## **BCMF SUBDIVISION**

APPLICATION NUMBER 10 DATE January 7, 2010

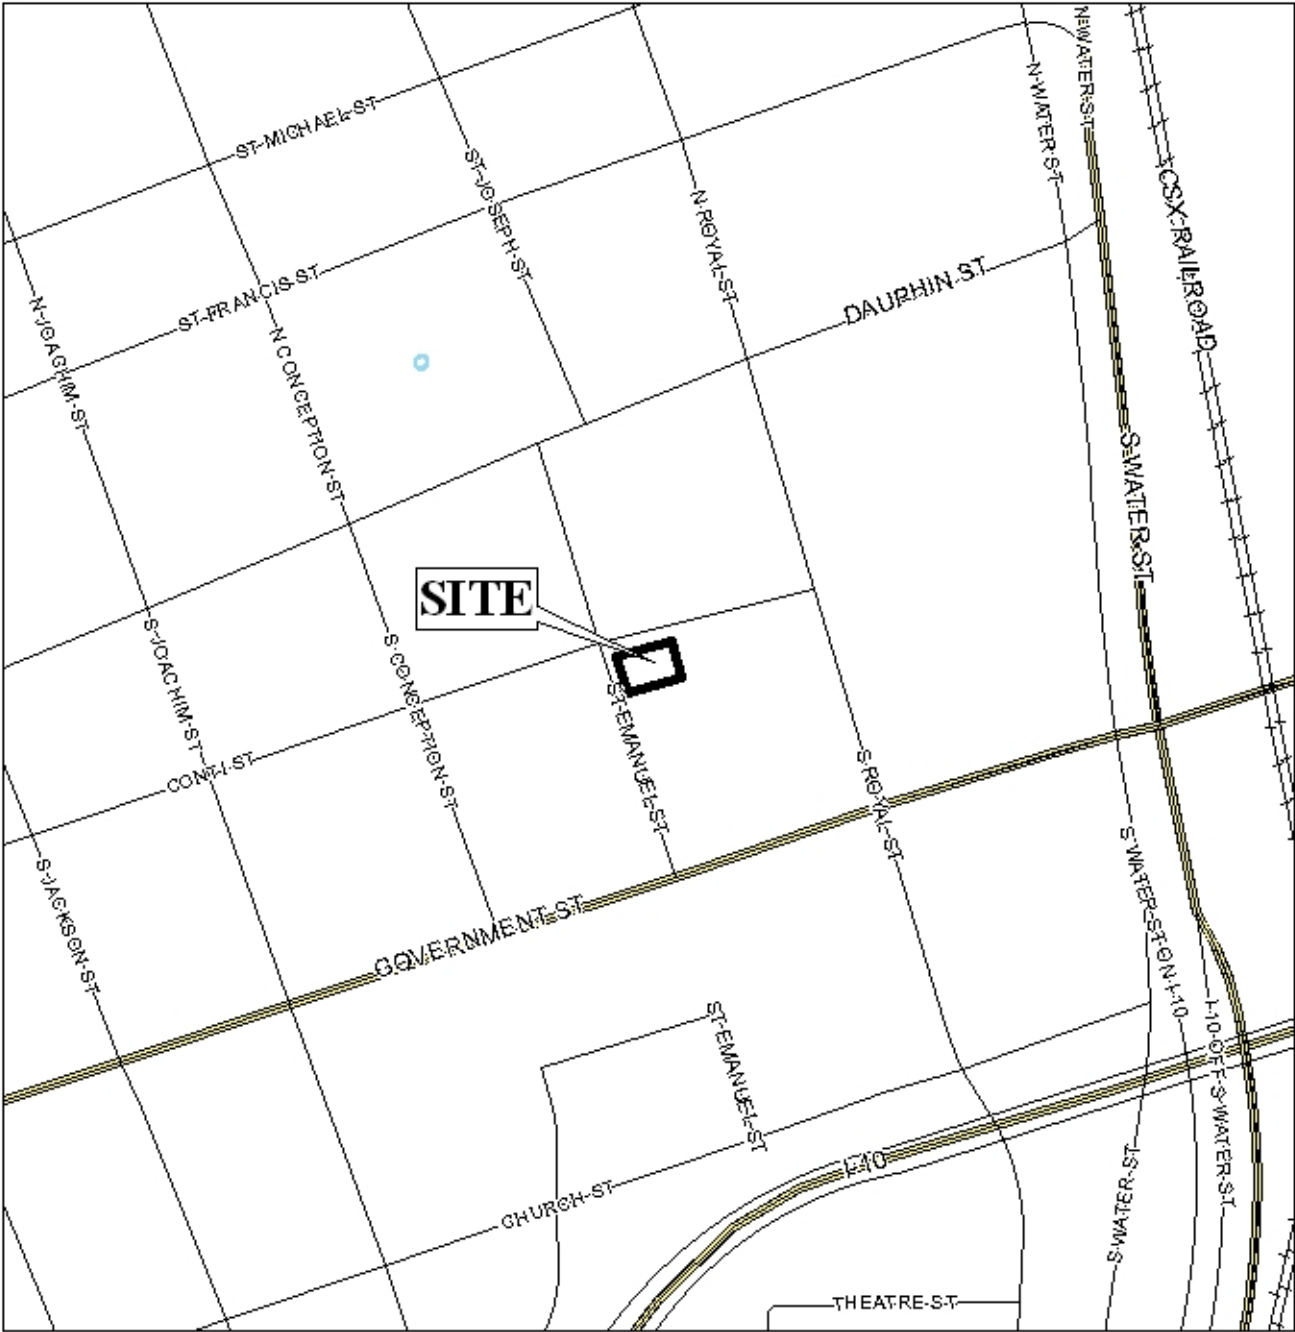
Engineering Comments: Site is located in AE Flood Zone; development must meet all FEMA requirements. Fill is not allowed without providing compensation (net fill of zero) or completing a flood study. Label Minimum FFE on Lot 1 of plat. Plat needs to include a minimum 25' radius for the property line at the intersection of Conti St & St Emanuel St. Must comply with all storm water and flood control ordinances. Any work performed in the right of way will require a right of way permit.

The site has frontage on Conti Street, a minor street with curb and gutter and a 44' of right-of-way per GIS data, and St. Emanuel Street, a minor street with curb and gutter and a 36' of right-of-way per the plat. Dedication has not apparently been required for other recent subdivisions along Conti or St. Emanuel Streets, even when the right-of-way is as substandard as at this site. As the site is in the downtown area, and as there are other existing buildings on both streets built to the right-of-way edge, the Planning Commission may wish to consider waiving Section V.B.14. of the Subdivision Regulations. It should be pointed out that the plat shows a 6' strip along Conti Street "dedicated by the city for public use," thus providing 24.8' from the centerline of Conti Street. Staff can not find the document in Probate, and requests a copy prior to signing the plat: it may be that land was dedicated to the city rather than by the city. The plat should be revised to label the right-of-way widths for both streets. It should be noted that Engineering requires the dedication of a 25' radius at the corner.

As a means of access management, a note should be placed on the final plat stating that the lot is limited to the only existing curb-cut along St. Emanuel Street with the size, location, and design to be approved by Traffic Engineering and conform to AASHTO standards.

The lot is not labeled on the plat with its size in square feet, and should be so-labeled on the final plat, but a table is provided furnishing the same information and should be retained, if approved. Lot size should reflect dedication.

- 1) placement of a note on the final plat stating that the lot is limited to the only existing curb-cut along St. Emanuel Street with the size, location, and design to be approved by Traffic Engineering and conform to AASHTO standards;

- 2) improvements to the site subject to MHDC/ARB approval;
- 3) labeling of the minimum and maximum right-of-way widths for each street;
- 4) submission of the deed information regarding dedication along Conti Street prior to signing plat, and correction of label if necessary;

- 5) placement of a note on the final plat stating that development of the site must be undertaken in compliance with all local, state, and Federal regulations regarding endangered, threatened or otherwise protected species;

- 6) dedication of a 25' radius at the intersection of Conti Street and St. Emanuel;
- 7) compliance with Engineering comments: *Site is located in AE Flood Zone; development must meet all FEMA requirements. Fill is not allowed without providing compensation (net fill of zero) or completing a flood study. Label Minimum FFE on Lot 1 of plat. Plat needs to include a minimum 25' radius for the property line at the intersection of Conti St & St Emanuel St. Must comply with all storm water and flood control ordinances. Any work performed in the right of way will require a right of way permit; and*
